SUPPORTING AMENDMENT NOS. 46 AND 29 TO

FACILITY OPERATING LICENSE NOS. NPF-4 AND NPF-7

NORTH ANNA POWER STATION, UNITS NO. 1 AND NO. 2

By letter dated December 8, 1982 (Serial No. 622), the Virginia Electric and Power Company (the licensee) requested an amendment in the form of changes to the Technical Specifications (TS) for Operating License Nos. NPF-4 and NPF-7 for the North Anna Power Station, Unit Nos. 1 and 2 (NA-1&2), respectively.

Figure 2.1-1 Reactor Core Safety Limits for Three Loop Operation,

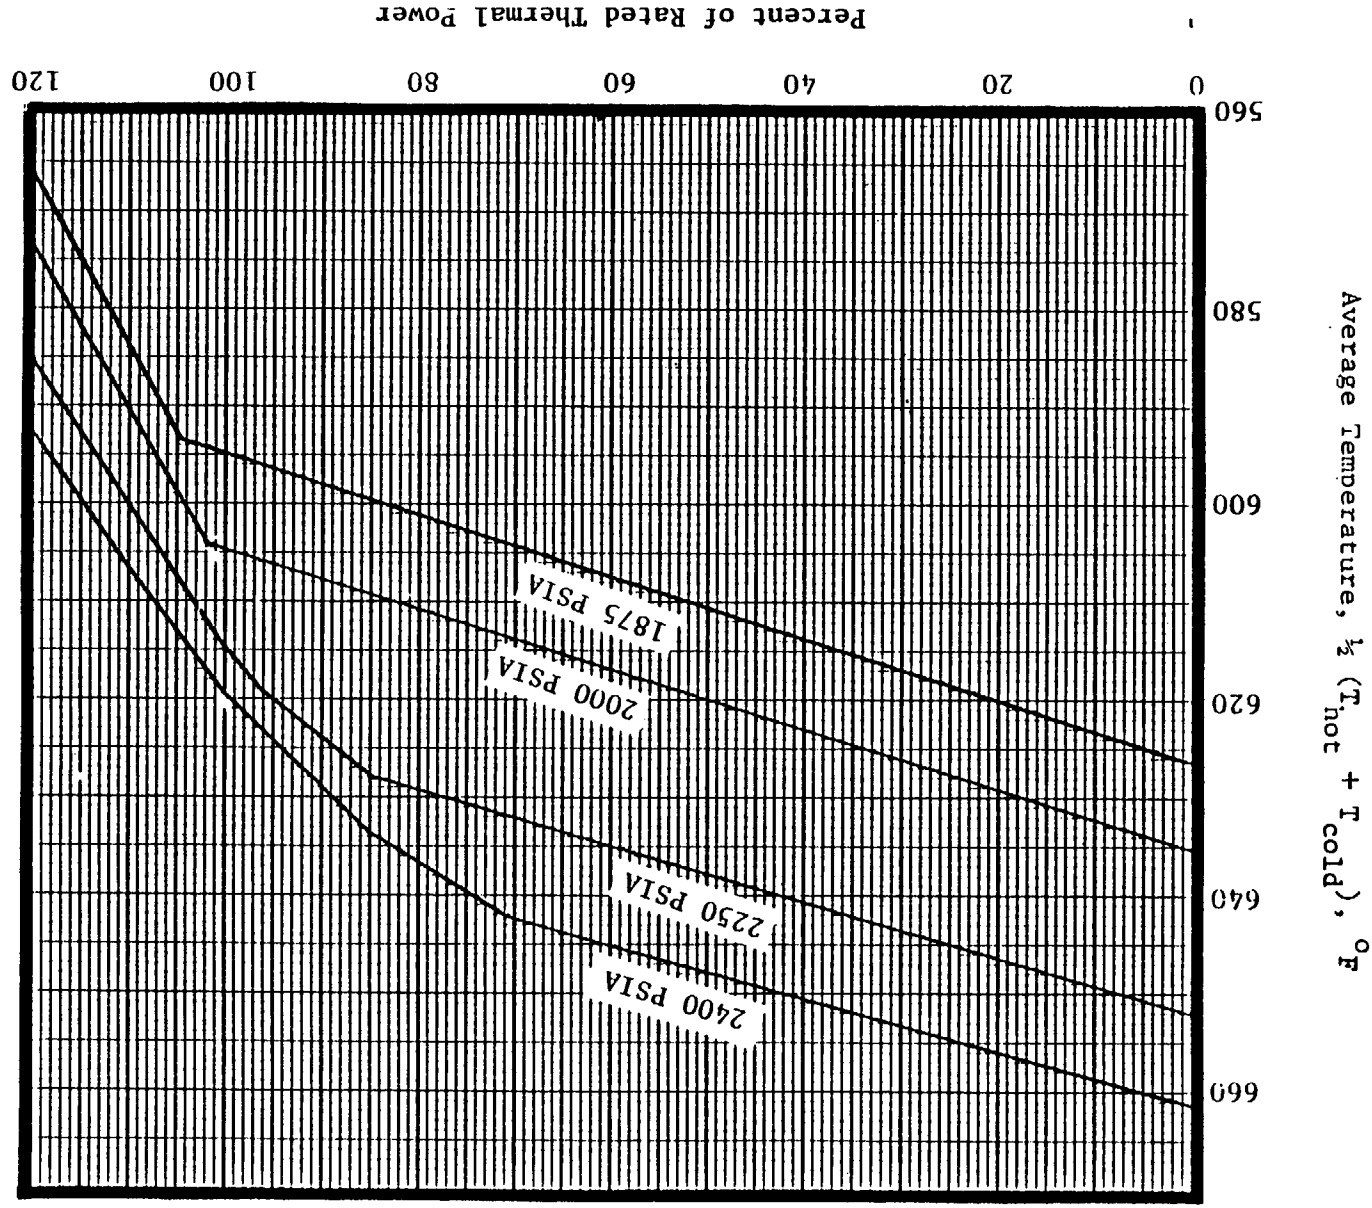
The curves of Figures 2.1-1, 2.1-2 and 2.1-3 show the loci of points of THERMAL POWER, Reactor Coolant System pressure and average temperature for which the minimum DNBR is no less than 1.30, or the average enthalpy at the vessel exit is equal to the enthalpy of saturated liquid.

The curves are based on an enthalpy hot channel factor, $F_{\Delta H}^N$, of 1.55 and a reference cosine with a peak of 1.55 for axial power shape. An allowance is included for an increase in $F_{\Delta H}^N$ at reduced power based on the expression:

$$F_{\Delta H}^N = 1.55 [1 + 0.3 (1-P)]$$

Figure 2.1-1 Reactor Core Safety Limits for Three Loop Operation,
100% Flow

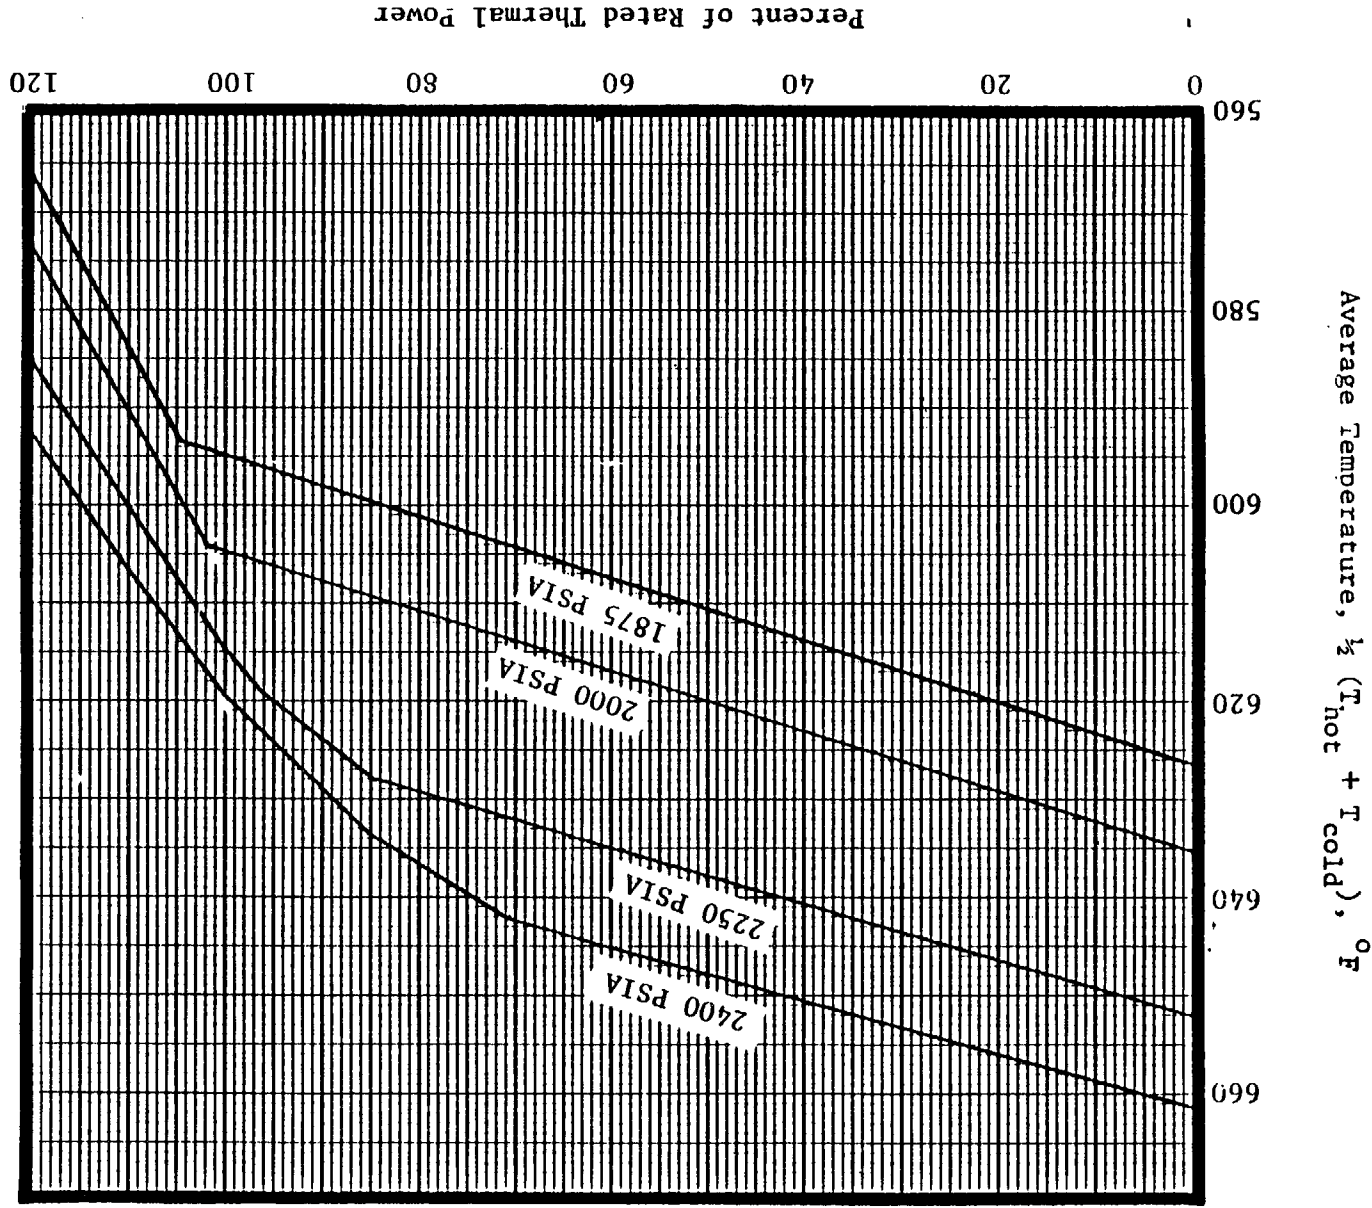
The curves of Figures 2.1-1, 2.1-2 and 2.1-3 show the loci of points of THERMAL POWER, Reactor Coolant System pressure and average temperature for which the minimum DNBR is no less than 1.30, or the average enthalpy at the vessel exit is equal to the enthalpy of saturated liquid.

The curves are based on an enthalpy hot channel factor, $F_{\Delta H}^N$, of 1.55 and a reference cosine with a peak of 1.55 for axial power shape. An allowance is included for an increase in $F_{\Delta H}^N$ at reduced power based on the expression:

$$F_{\Delta H}^N = 1.55 [1 + 0.3 (1 - P)]$$
